## Community proposals for the Westlake Cycle Track and SDOT responses

Oct. 22, 2014

### Overview

Arne Levang submitted the below drawing to SDOT at DAC meeting #3 on April 21:

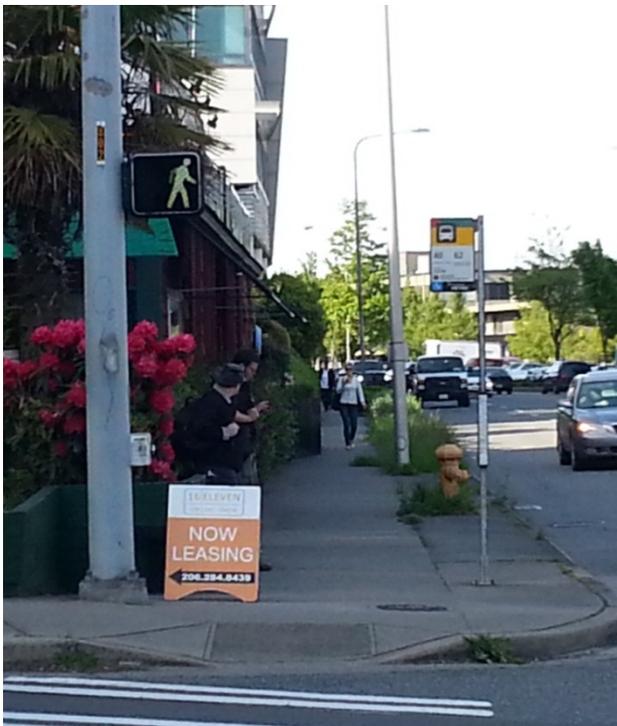
- SDOT presented Arne Levang's idea at DAC meeting #5 on June 23. In this concept, the bicycle facility is in the center of the parking lot drive aisle. It has a 6' wide smooth area which encourages cyclists to ride in the center with speed humps in the parking lot with back-in angled parking.

- SDOT reviewed the idea and appreciated that it adds predictability to the corridor. However, it does not physically separate bicyclists from vehicles, so it doesn't address safety or encourage "willing but wary" bicyclists. Where motorists cross the cycle track is not predictable.

- Elements SDOT considered moving forward were the safety aspect of slowing speeds of motorists in the drive aisle, discouraging cyclists from using the drive aisle with by using speed humps, and considering the safety element of back-in angled parking.

- SDOT worked from Arne's idea to explore the "Center Concept" which SDOT presented at DAC meeting #6 on July 28.

Jack Wilken submitted the proposal and drawing below to SDOT on Aug. 10:

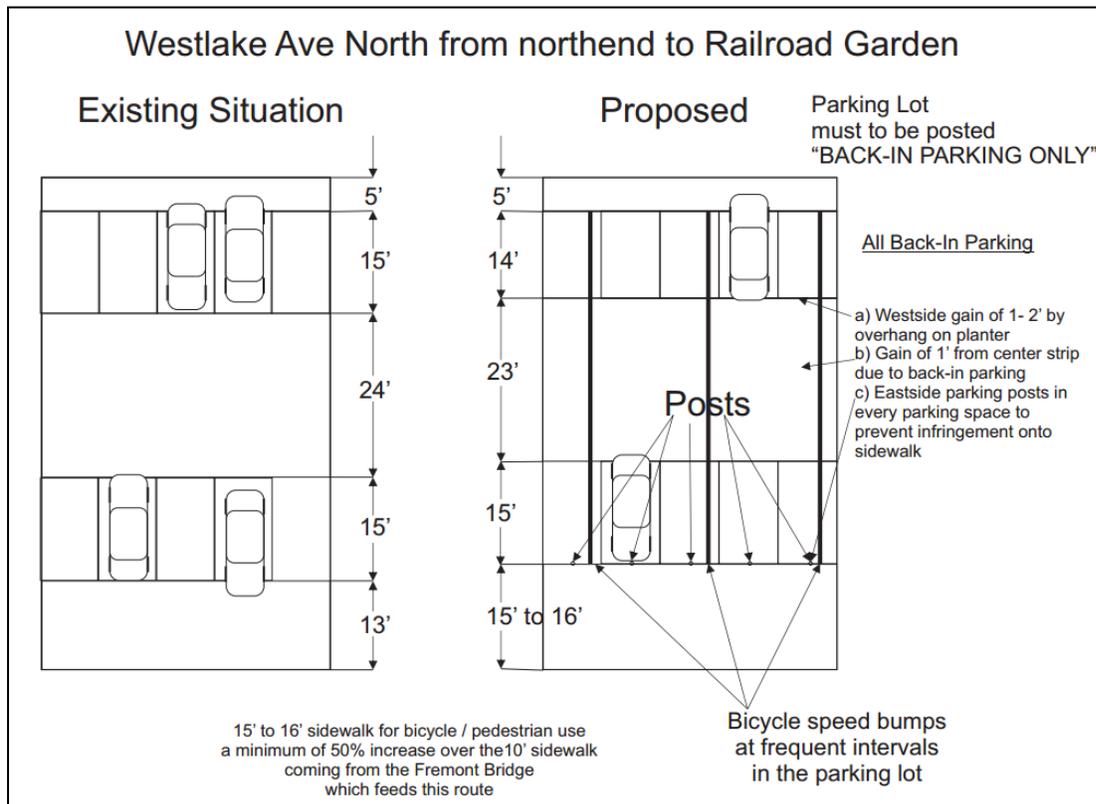
From the Fremont Bridge to the north entrance of the Westlake Ave North parking lot, there is a 10' wide sidewalk that accommodates the flow of bicycle and pedestrian traffic. This has not been a conflictive area as far as accidents between these two transportation modes.

We are proposing this theme be continued in the parking lot until the "Railroad Garden" with an additional 50% in width to the sidewalk. This sector of the corridor does not have a service lane which could be converted to a protected cycle lane. Even a 5% loss of parking would threaten the businesses in this sector with a loss of revenue that would create a catastrophic domino effect. The city's own norms call for 1 parking space per every 2 boat slips adjacent to marinas; this does not take into account additional businesses or liveaboards. We are already at or below this norm. The historic conflict in this sector has been between high speed cyclists & cars, cyclists that ride close to the parked cars and the cars exiting parking spaces, or pedestrians & cyclists in the parking lot. (Cyclists on the side walk give way to pedestrians.)

For this reason, measures such as bike bumps the full width of the parking lot are an important part of any discussion about safety.

- Project staff met with Jack Wilken to discuss his proposal.
- SDOT analyzed some of the advantages of the concept including:
  - Retains perpendicular parking and maximizes parking supply

- Back-in parking better accommodates vehicle overhang and increases visibility
- SDOT also analyzed some of the challenges of the concept including:
  - Currently many truck drivers with larger vehicles back into parking spaces on the west side of the parking area to take advantage of the landscape buffer for vehicle overhang

- Need to maintain existing planting strip width adjacent to Westlake to accommodate vehicle overhang (see photo below)
  - 15-16' sidewalk may not be wide enough to accommodate bicycles and pedestrians

- Lack of space and separation from pedestrians may shift bicyclists into the parking area; the sidewalk connecting to Fremont Bridge functions adequately as all travel by pedestrians and bicyclists is parallel to the sidewalk, that is there is no cross pedestrian traffic as in the business, marina, residential areas in the corridor.

- SDOT did incorporate speed bumps in the drive aisle into the cycle track alignment.
- SDOT will work with the community to identify possible constrained areas where narrowing and shortening parking stalls may be appropriate.

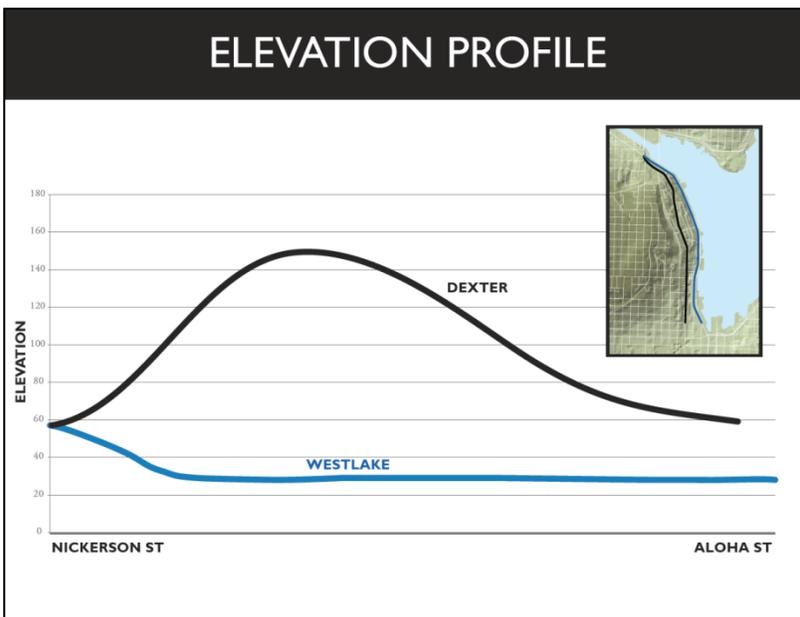
- The condition is very similar to what exists today – which has issues that the design team is working to address
- The southbound bicycle facility (which in your proposal is a shared 6' wide sidewalk) does not meet the project goals and objectives.

- The southbound bicycle facility may not be used by bicyclists as it would be less attractive and convenient than riding in the parking area – many cyclists destined for South Lake Union or on recreational rides will not cross Westlake Ave N and instead will stay in the parking area.

- This would require additional crossings of Westlake Avenue North which has an impact on traffic mobility on Westlake Ave N.
- There are encroachments in the right-of-way on the west side of Westlake Ave N that would have to be removed.

- Further south, there is development up to the right-of-way line creating conflicts.
- There are pedestrian conflicts on the west side sidewalk – the sidewalk is more heavily used at the south end of the corridor.

- Motorists and pedestrians may not anticipate bicycle traffic on the constrained sidewalk.
- There are utility conflicts in the sidewalk, not only limited to fire hydrants, but street light poles.

- There are other areas of unstable hill side along the west side creating challenges to maintaining the existing sidewalk.

- A buffer would be required between the curb travel lane and the bicycle facility.

The project team is moving forward with the Sidewalk Concept and will continue to work with the community to best accommodate everyone's needs. The Sidewalk Concept aims to preserve about 80% of the parking in the corridor and SDOT is including parking management as part of the project in order to make better use of the existing parking.
